Discussion on increasing the Schnupp asymmetry

A preliminary document exploring allowable ETM's & ITM's mechanical clearances along the beam center line & the feasibility of cookie cutter 'BLANKS' for the following chambers:

BSC10-H1 (ETMY) CURRENT:

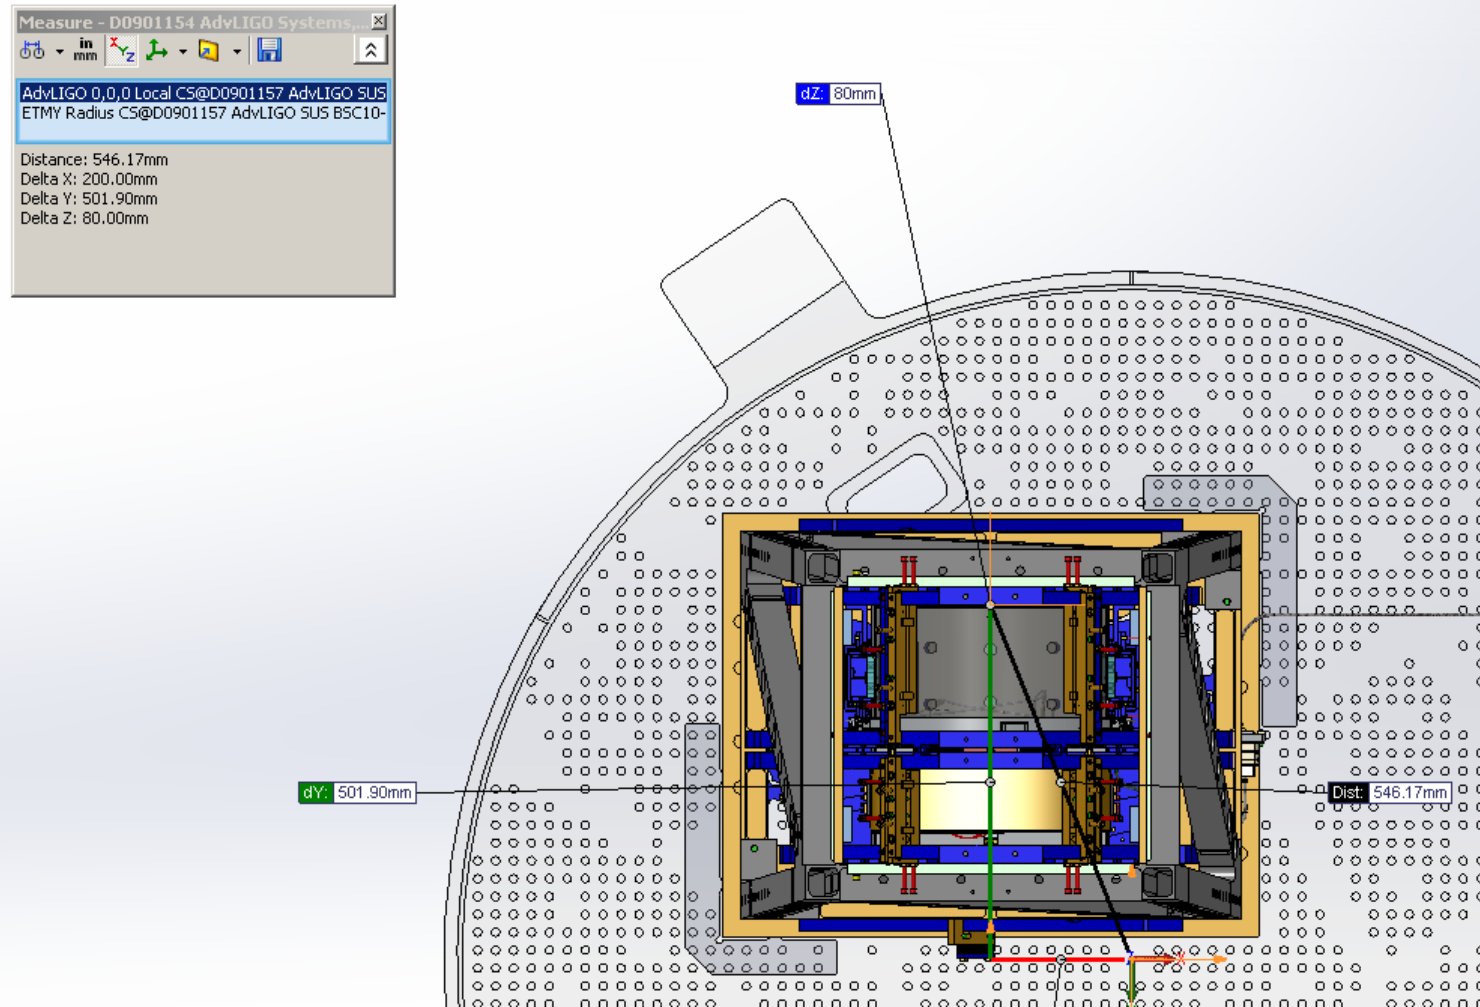
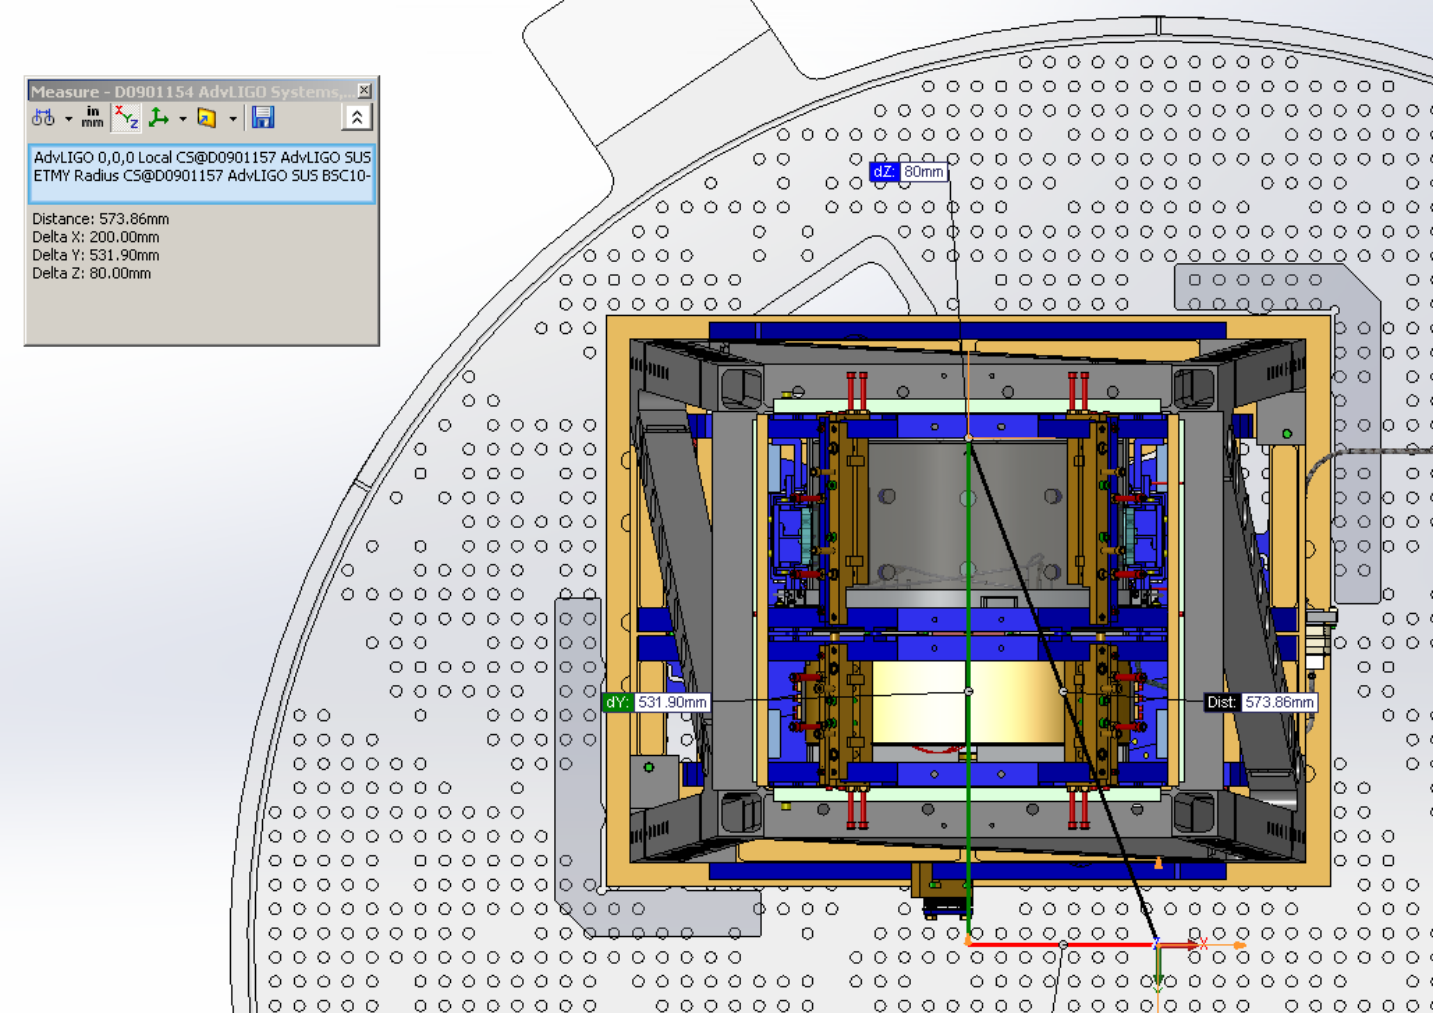
Distance: 546.17mm
Delta X: 200.00mm
Delta Y: 501.90mm
Delta Z: 80.00mm

BSC10-H1 (ETMY) Schnupp Effect: 30mm Toward GLOBAL 0

Distance: 573.86mm
Delta X: 200.00mm
Delta Y: 531.90mm
Delta Z: 80.00mm
